THIRD PARTY INSPECTION REPORT
FOR
CONSTRUCTION OF NEW BUILDING FOR
SCIENCE DEPARTMENT

AT
C.S.J.M. UNIVERSITY CAMPUS
KANPUR

Submitted to:
Executive Engineer U.P. R.N.S.S.
5/750 SECTOR-5 GOMTI NAGAR
LUCKNOW

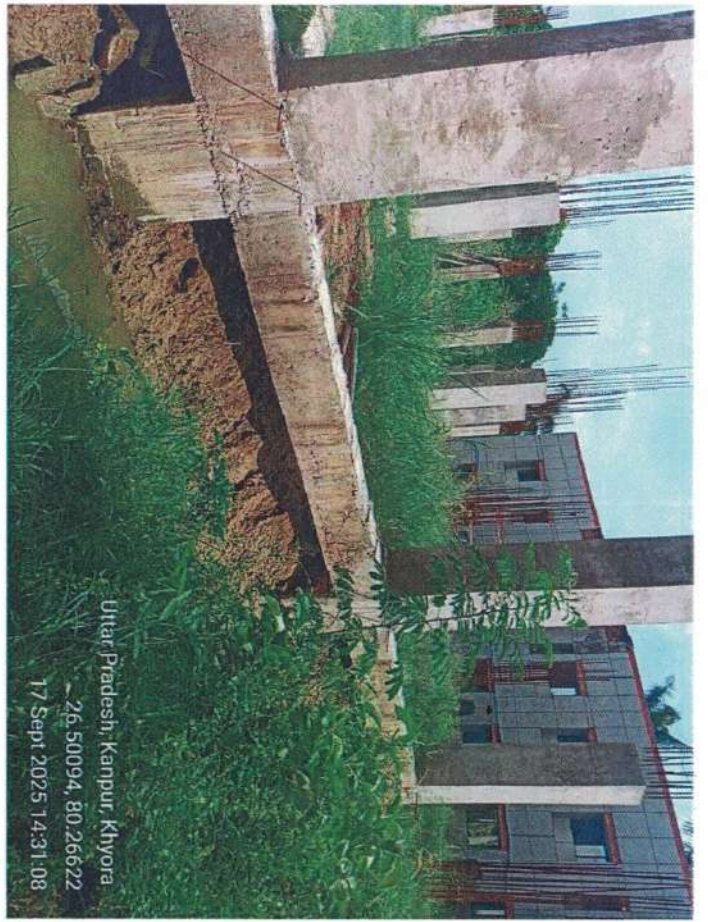
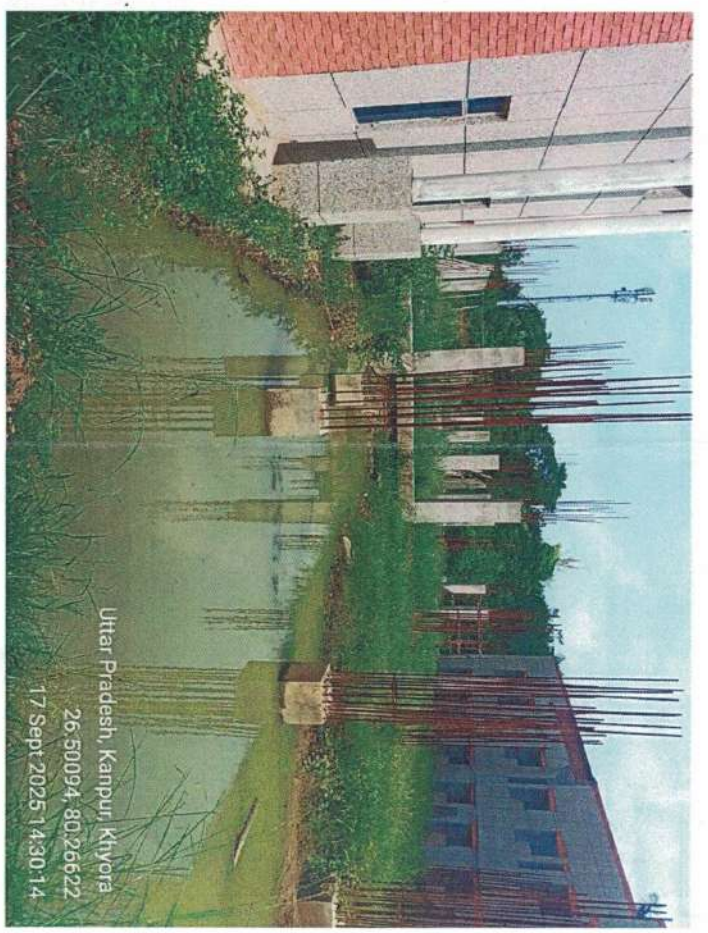
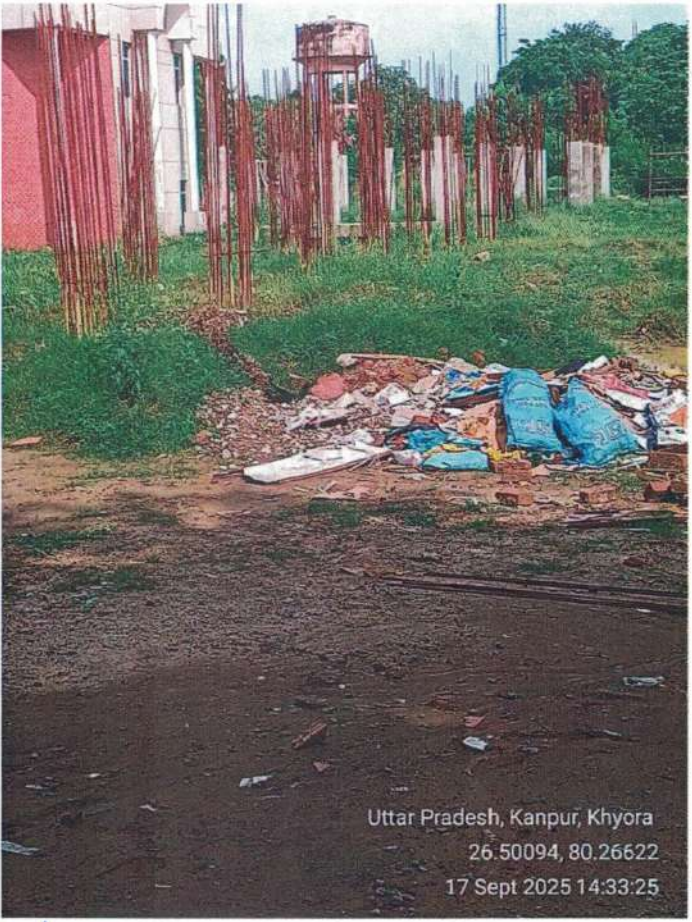
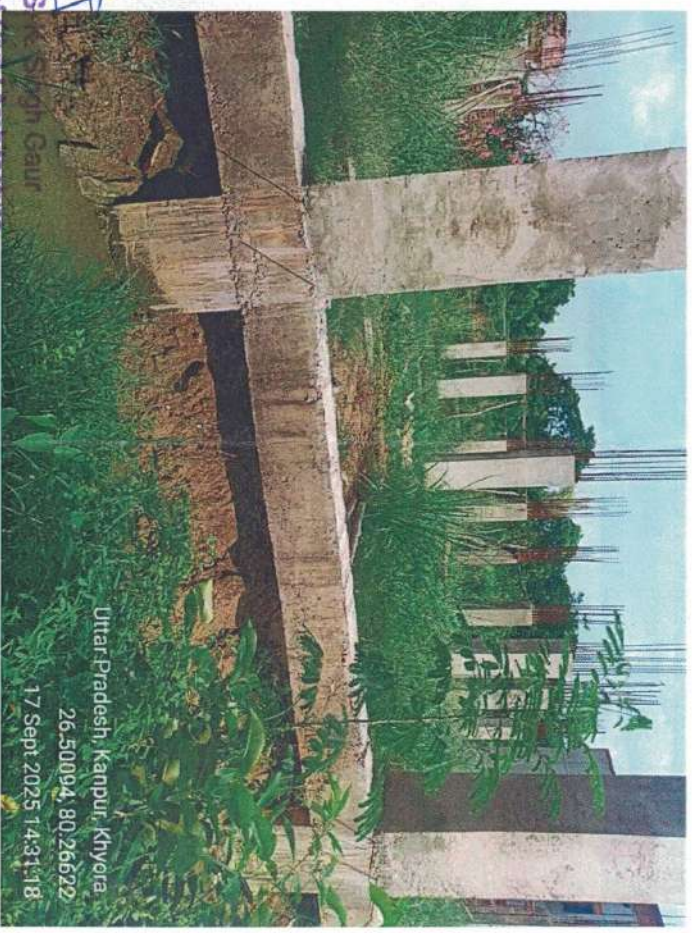
During site visit, It was observed that the building under consideration is in construction stage. All footings have been casted as per approved layout drawings. All plinth beams have been casted with partial construction of dwarf walls where ever needed. Almost 50% columns have been casted up to lintel level with remaining columns ready for casting. Reinforcement used for columns was found to be as per approved structural drawings. Structural drawings and analysis presented by UPRNSS

indicated that these drawings have been prepared for G+3 floors, though only ground floor is under construction presently. Total covered area on ground floor is around 1675 Sqm. Proper overlaps were found in longitudinal reinforcement of columns though stirrups were not provided/ tied in uncasted columns. Bar bending site was inspected for rebaring of structural members and it was found satisfactory. Construction agency was asked to produce the design mix report for proposed mix of concrete. It was informed by the contractor and UPRNSS that they are using ready mix concrete even then they were instructed to get an approved design mix report of concrete and testing report of major concrete castings along with other relevant material testing reports.
